BID Addendum-01

Project No.
JCDT23-0185

Title
Bid Clarification 01

Project Name
St Clair County Heath Dept Relocation

PROPOSED SITE PLAN
SCALE: 1" = 20'-0"

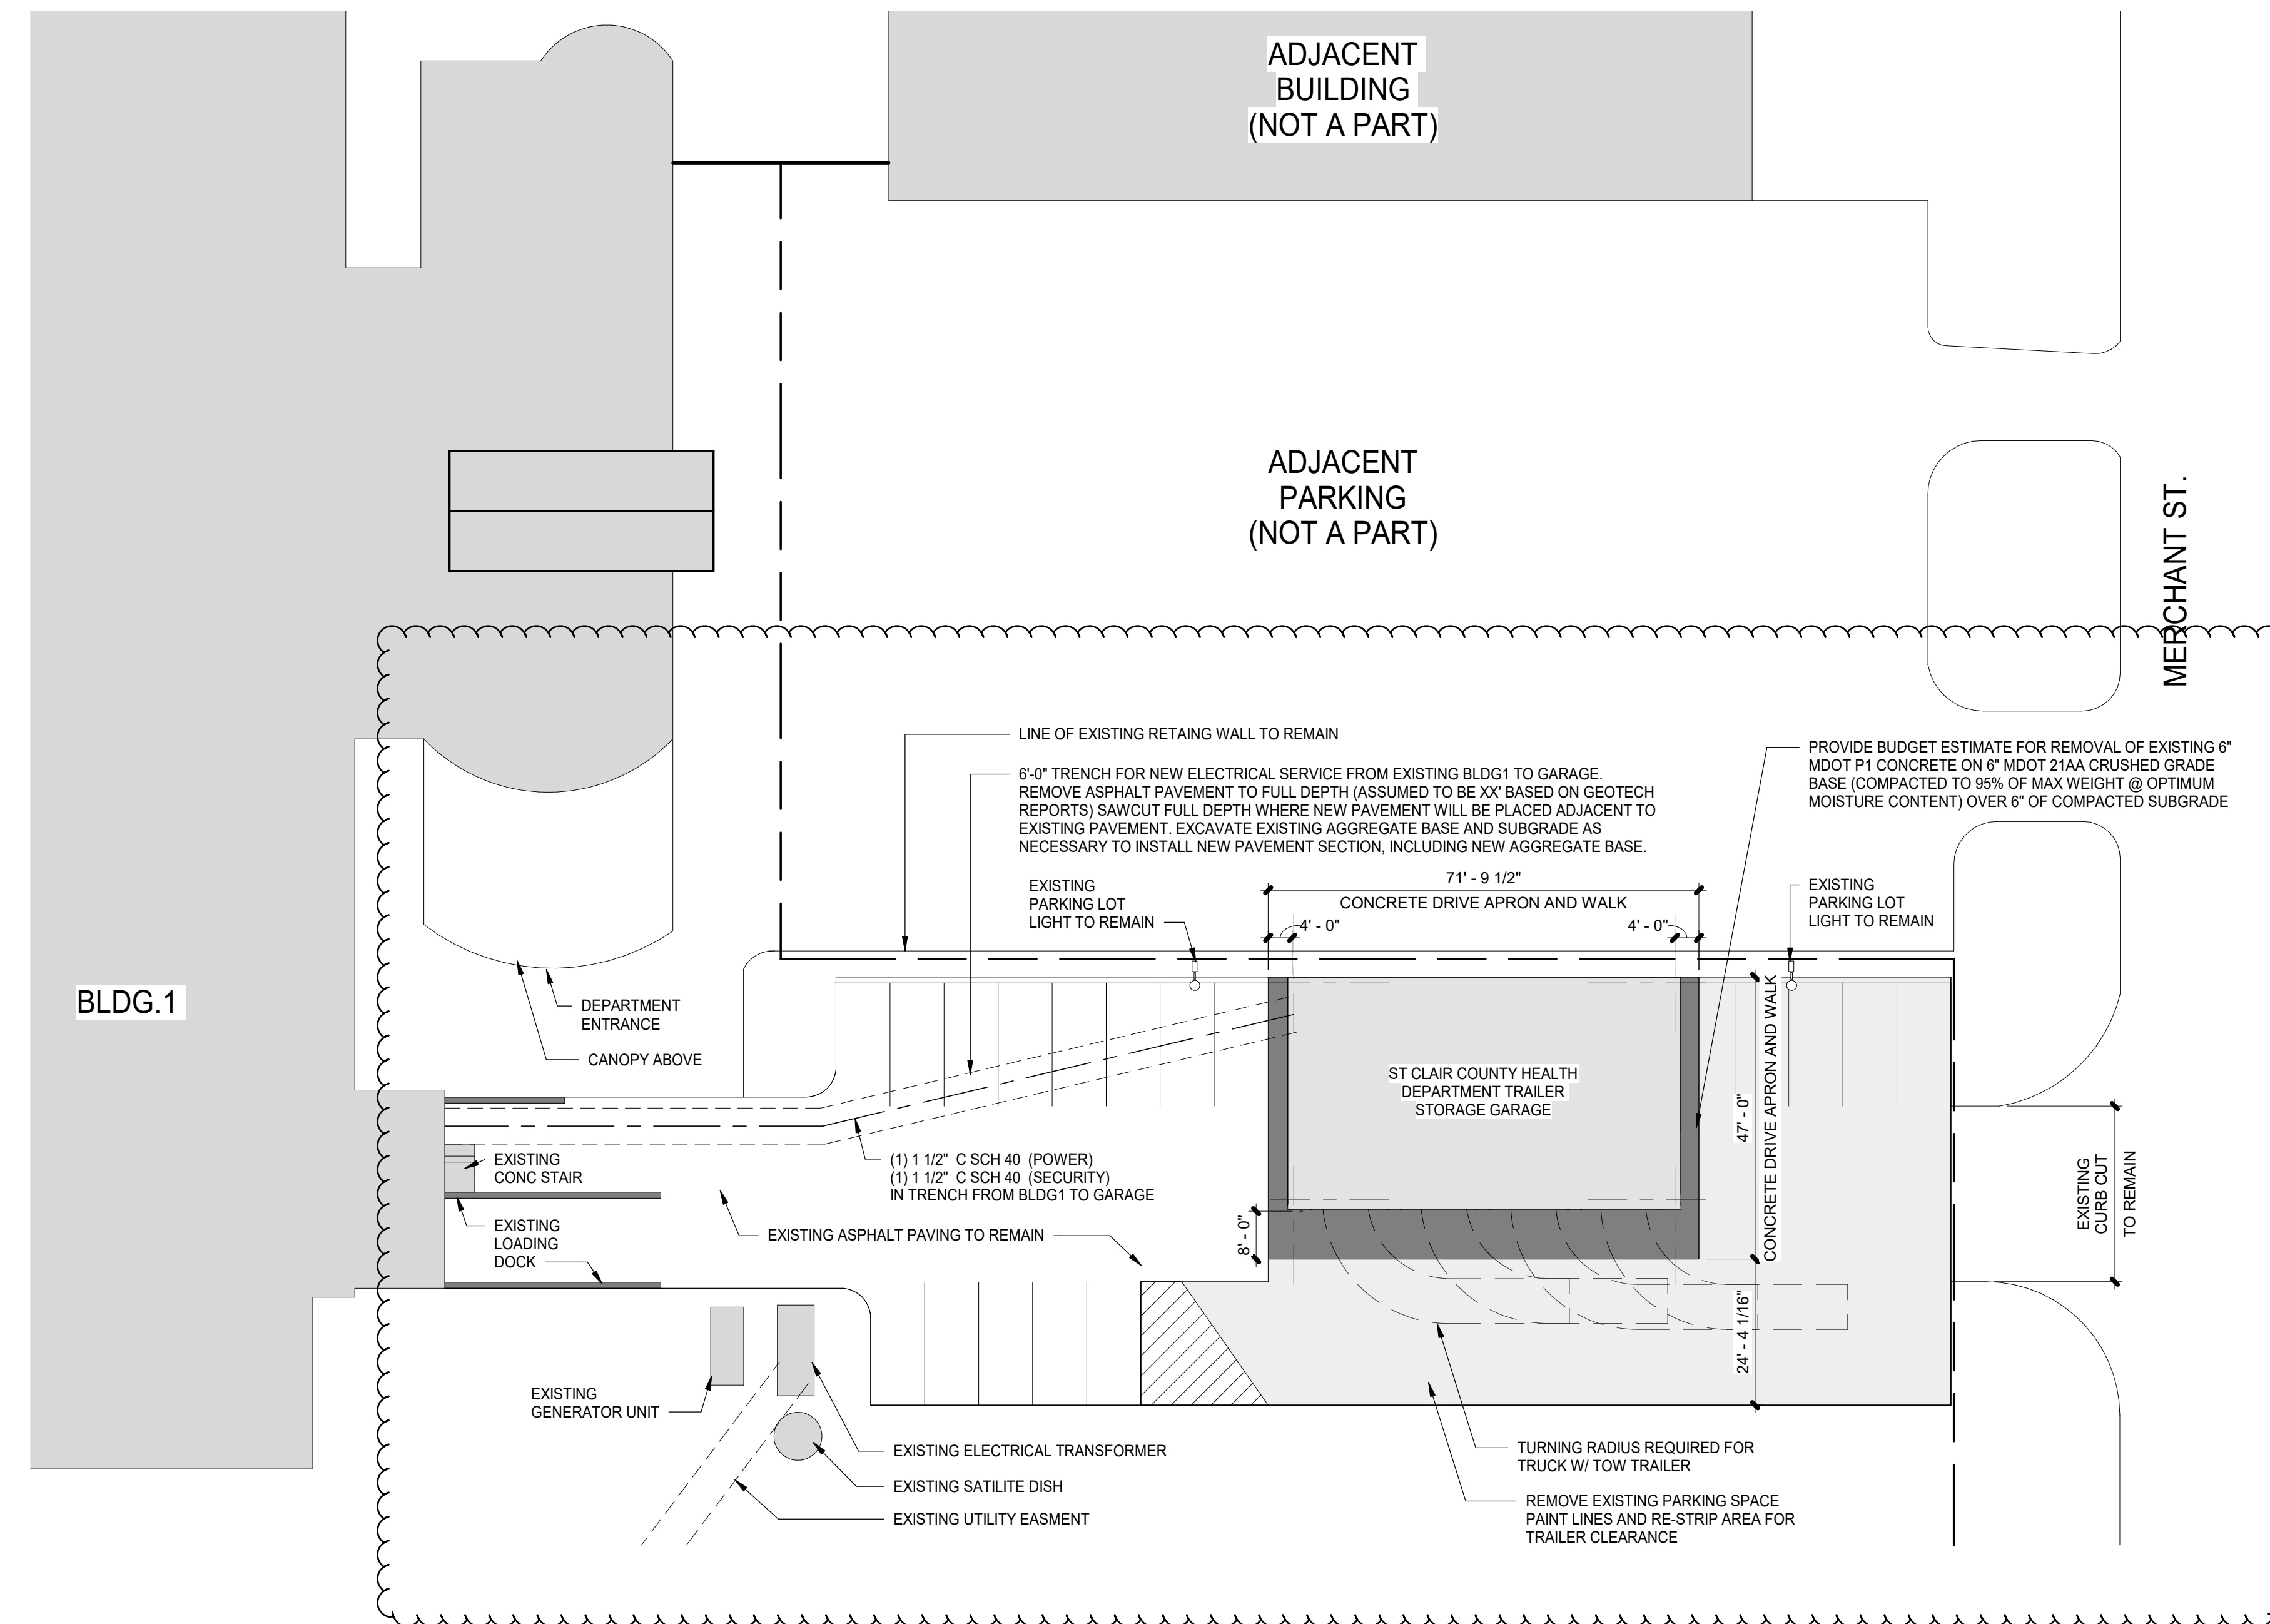
18.	Please identify what of the existing asphalt is to be removed on Drawing A10-0. Also please provide Civil Drawings per the note for the electrical trench	SCC HD Garage sheet A10-01 has been revised to clarify area of new concrete paving. Asphalt is being re-stripped. Provide allowance for estimated civil scope bid assessment.

1. Sheet A10-01 – ARCHITECTURAL SITE PLAN
 - a. Revised sheet to include site plans details as indicated.
 - b. Revised Site Plan to include notes as indicated.
2. Sheet A21-02 – FLOOR, LIFE SAFETY, RCP AND ROOF PLANS
 - a. Revised plan to include Fully Adhered 0.60 EPDM roofing system and 2:12 roof pitch as indicated.
3. Sheet A40-01 – EXTERIOR ELEVATIONS AND SECTIONS
 - a. Revised sections to include 2:12 pitch roof as indicated.
 - b. Revised sections to include metal hood for coiling doors as indicated.
 - c. Revised elevations to exclude vision panels.
4. Sheet A42-01 – WALL SECTIONS
 - a. Revised wall sections to include 2:12 roof pitch and Fully Adhered 0.60 EPDM roofing system as indicated.

2 GARAGE - ROOF PLAN
SCALE: 1/8" = 1'-0"

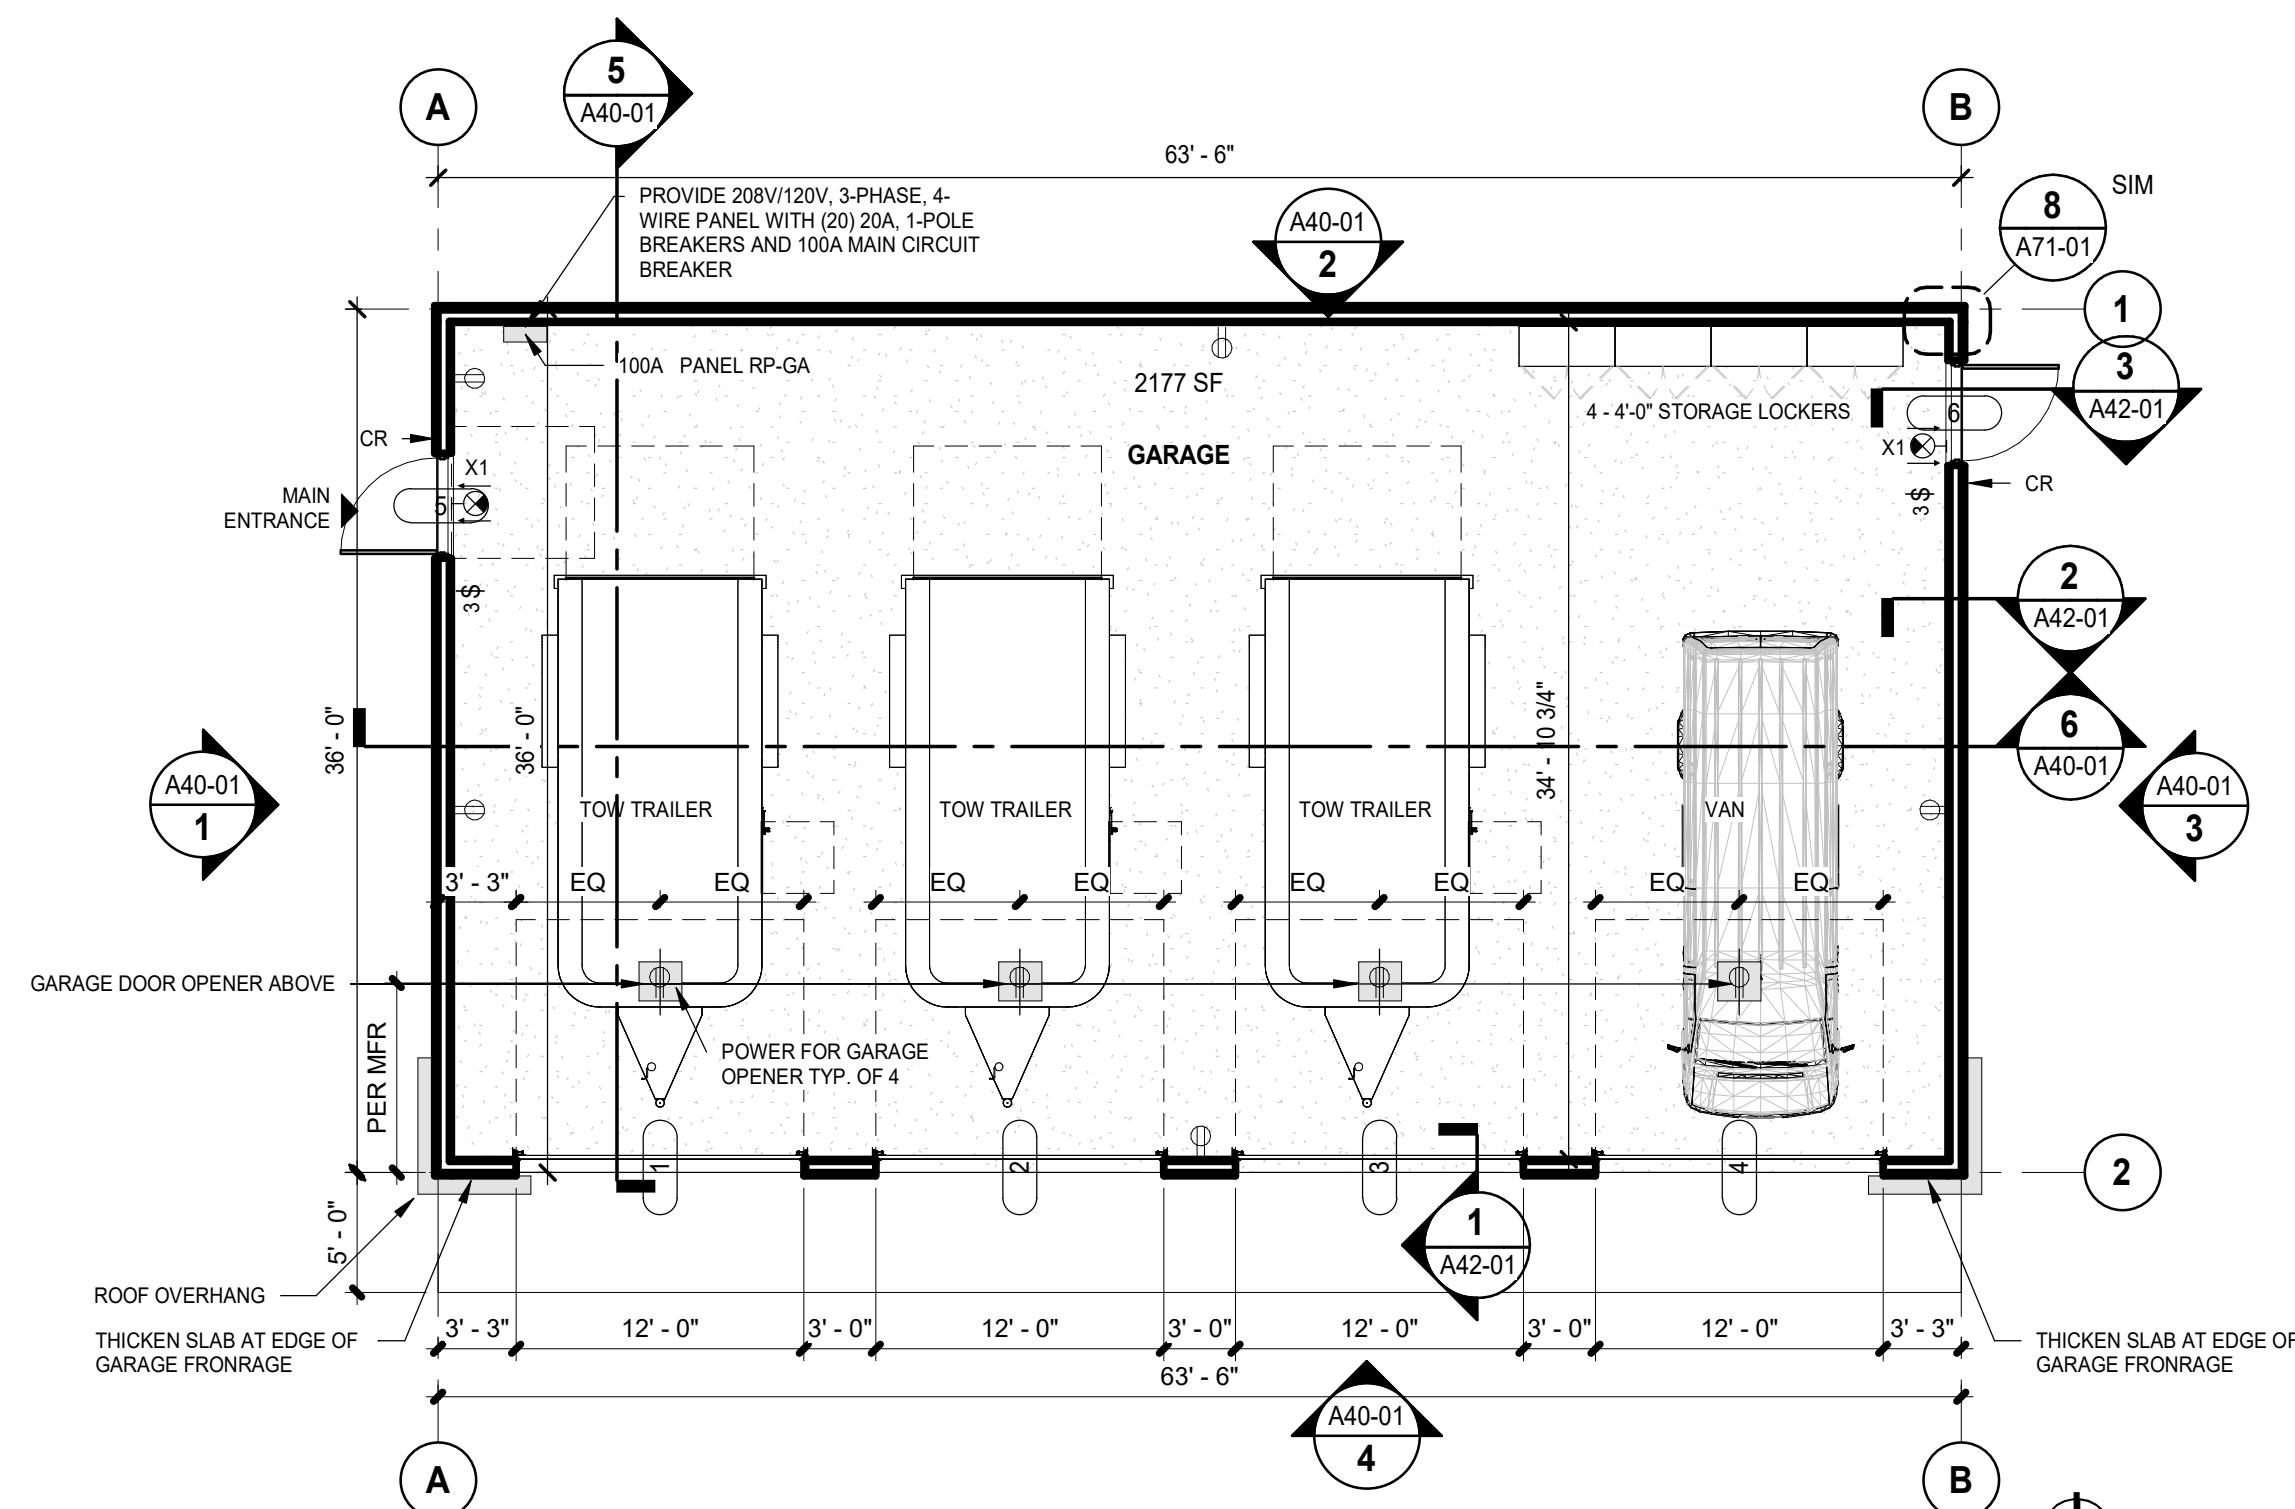
<p>8.</p>	<p>The garage building roof calls out for shingles, but the roof appears to be roughly a 1:12 pitch. Shingle manufacturers typically will not give a warranty for their products to be applied to anything less than at least a 2:12 or 3:12 pitch. Can you verify that shingle roofing is intended on this application?</p>	<p>Garage roof to be using a Fully Adhered 0.60 EPDM roofing system. Specification 075323 Single-Ply Roofing issued as a part of the 5/9/2024 Bid Addendum.</p>
<p>9.</p>	<p>Regarding the demolition on the second floor, please clarify if the light fixtures and the acoustical ceiling tile are to be removed.</p>	<p>Extend of 2nd Floor ceiling (Keynote AC50) is limited to location where the new lab is being installed. Remainder of existing ACT ceiling and Grid to remain. All lighting fixtures are being removed and replace per electrical plan E81-02.</p>
<p>10.</p>	<p>Spec Section 102800 indicates to match the building/owner standards for the following, (Toilet Paper Dispenser, Soap Dispenser, Toilet Seat Cover Dispenser, Sanitary Napkin Dispenser, Paper Towel Dispenser), please provide manufacture and model numbers for building/owner standards.</p>	<p>See Toilet Accessory Schedule on sheet A60-04 for manufacture and model numbers for building/owner standards.</p>

14.	Please advise if there is an existing warranty on the Roof and who the manufacture is.	Garage roof to be using a Fully Adhered 0.60 EPDM roofing system. Specification 075323 Single-Ply Roofing issued as a part of the 5/9/2024 Bid Addendum.

5 TRANSVERSE SECTION
SCALE: 3/16" = 1'-0"

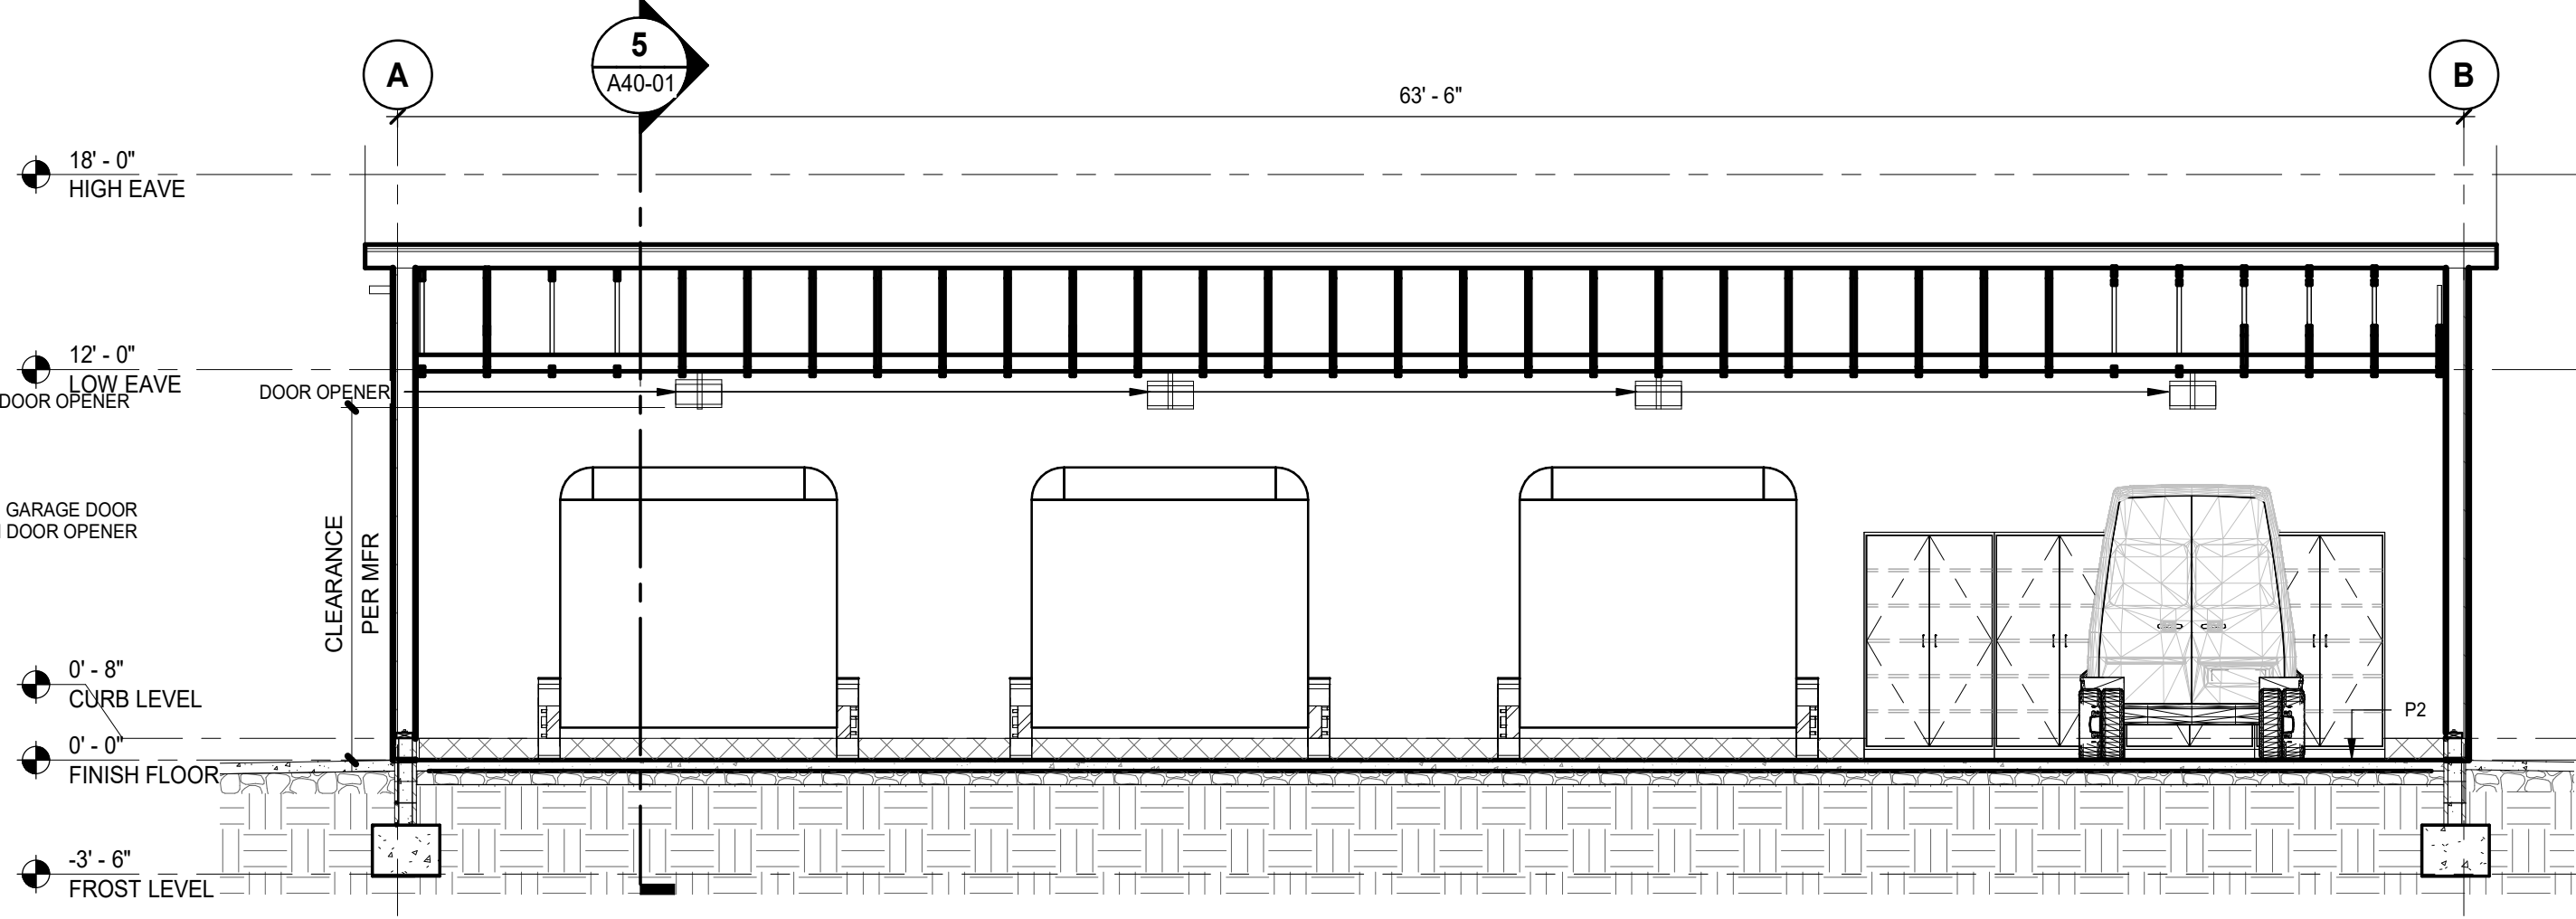
20.	Upon review, we did not find any written specifications for these (garage) doors; please clarify. The elevations and section 5 on A40-01 are shown to be sectional doors with windows and section 1 on A42-01 with the door schedule indicates coiling doors. Please clarify which type is required. If there is coiling, does the owner want vision panels; please clarify. Will the owner accept alternate manufacturers seeing there is only one indicated on the door schedule; please clarify	Specifications 08 3323-RIB-Overhead Coiling Doors issued as part of Bid Addendum. Overhead Coiling door to be used. Vision panels are not required. Alternate manufactures are acceptable.
